Subject: **NEDO-33083-A, "TRACG Application for ESBWR," October 2005  
(TAC # MC8168)**

1. MFN 05-127 – NEDO-33083-A, "TRACG Application for ESBWR," October 2005

# **TRACG Application for ESBWR**

Figure 333-1 Theoretical Sonic Velocity for HEM of Steam and Water

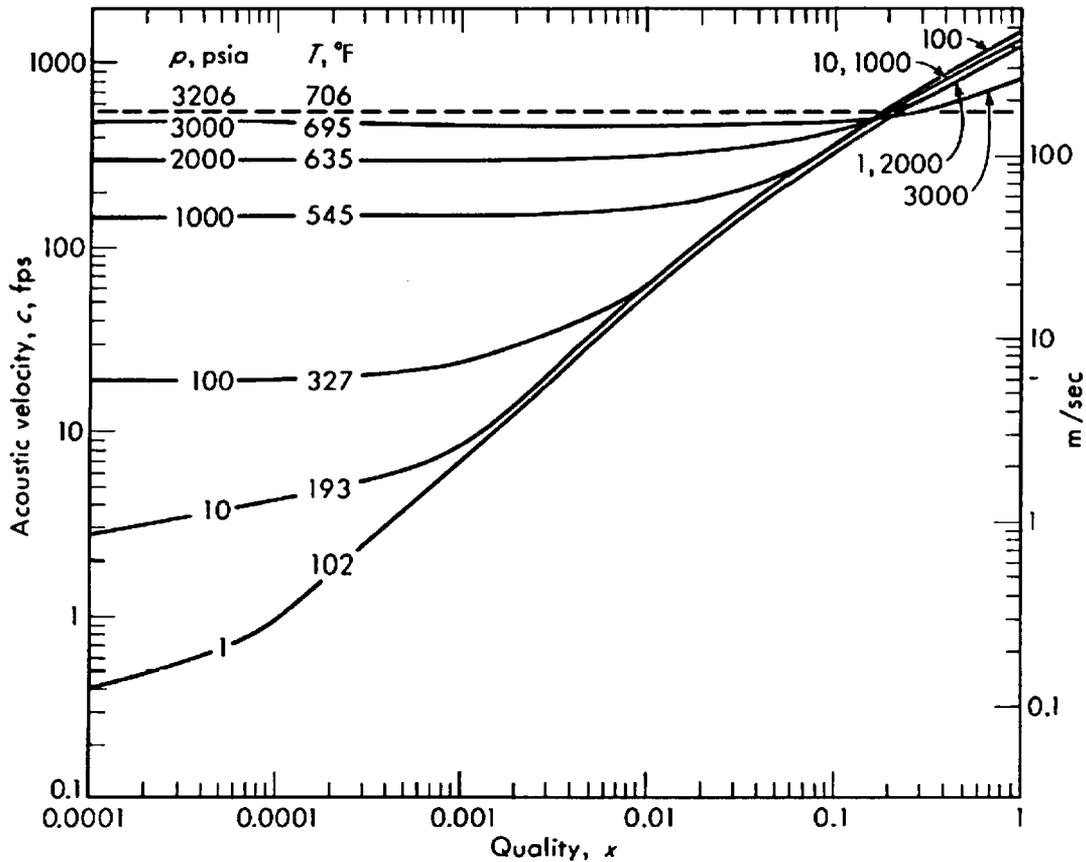
Q333. In order to verify the TRACG critical flow model, we have developed and run a simple test problem. It consists of two break components and a pipe component. Two break components define the pressure boundary conditions (73 bar upstream and atmospheric pressure downstream). A pipe with an orifice at the center was initially set to 73 bar through out its entire length. Then, the downstream break is depressurized to atmospheric pressure. The TRACG code predicts choke condition at the orifice. However, the calculated fluid velocity at the choke point is only about 60 meters per second. Usually, the sound speed is expected to have be on the order of 100 - 300 meters per second. Therefore, the calculated choke

A proof of the adequacy and applicability of the TRACG critical flow model is the qualification against separate effects critical flow experiments that is documented in Section 3.4 of NEDE-32177P, Rev. 2. The Edwards blowdown problem described in Section 3.4.3 is a good one to consider both because of its simplicity and because it involves critical flow for a wide range of void fractions. Selected calculated results are compared to test data in Figures 3.4-16 and 3.4-17 of NEDE-32177P, Rev. 2. The TRACG input deck for the Edwards blowdown problem is transmitted in the separate ASCII file named "EDWARDS.INP". The corresponding pressure and void fraction data are contained in the ASCII file named "EDWARDS.DAT".

Figure 187A GDCS Equalization Line

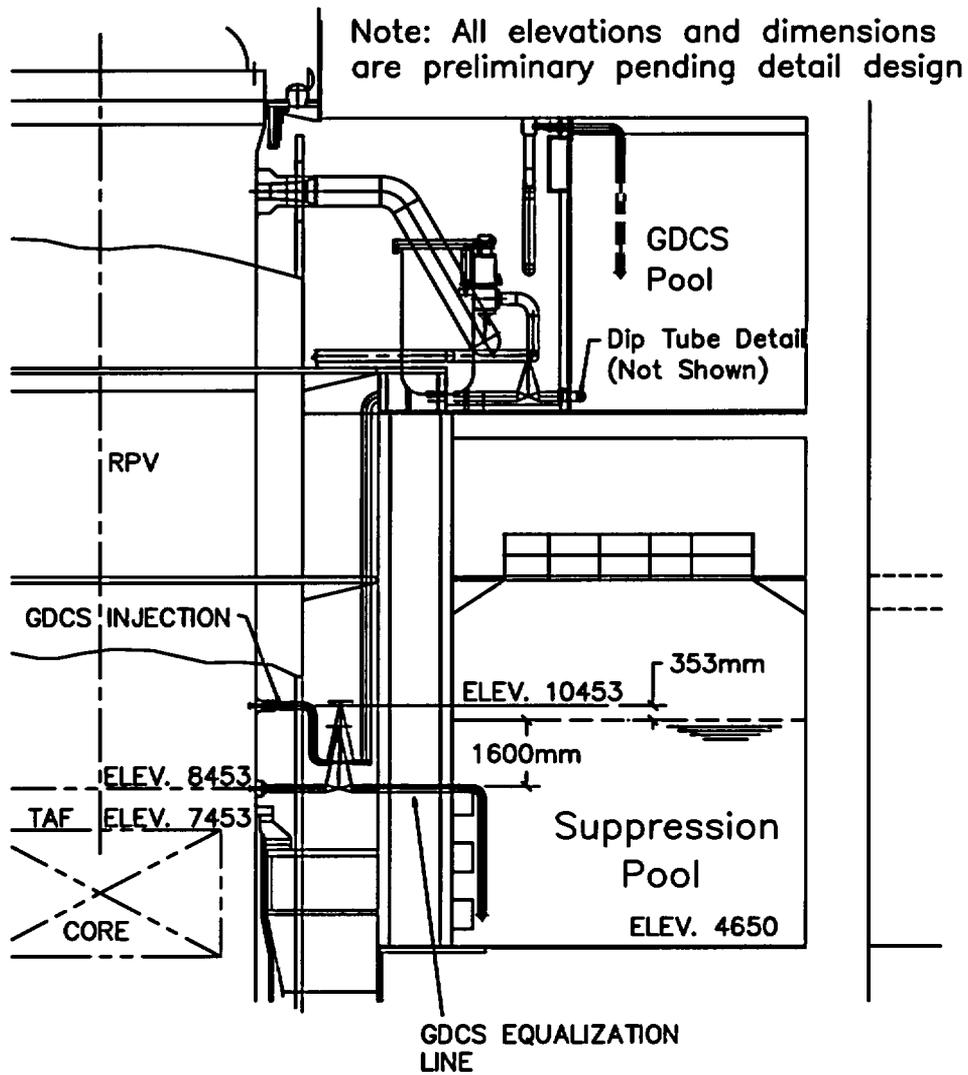
R187. Please see Figure 187A and Figure 187B for details.

**Figure 101-1. NEDE-32177P Figure 3.4-8 Comparison of Break Flow for Marviken Test 24**

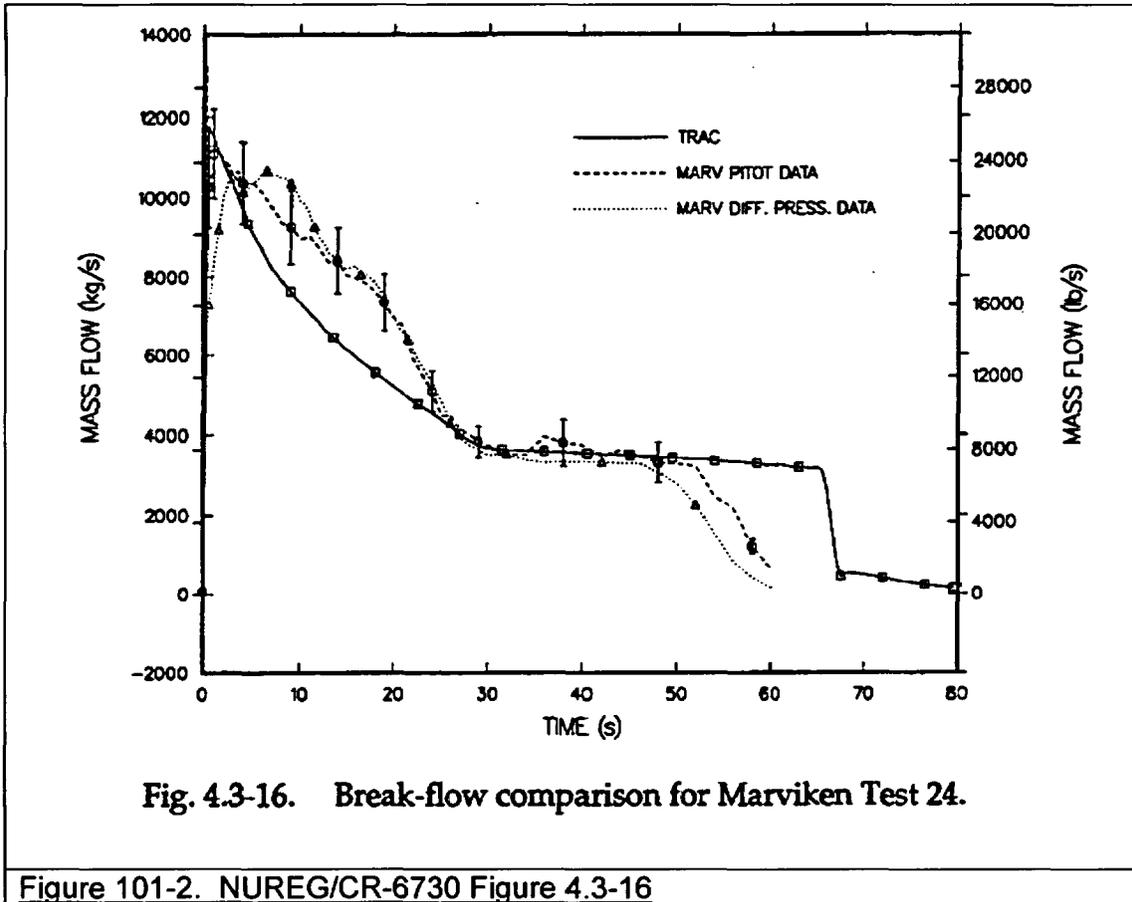
Q102. Section 3.4.1.5 (p. 3-56) - In Figure 3.4-8, what is the cause of the 20 second delay in the TRACG prediction of the transition to pure steam flow?
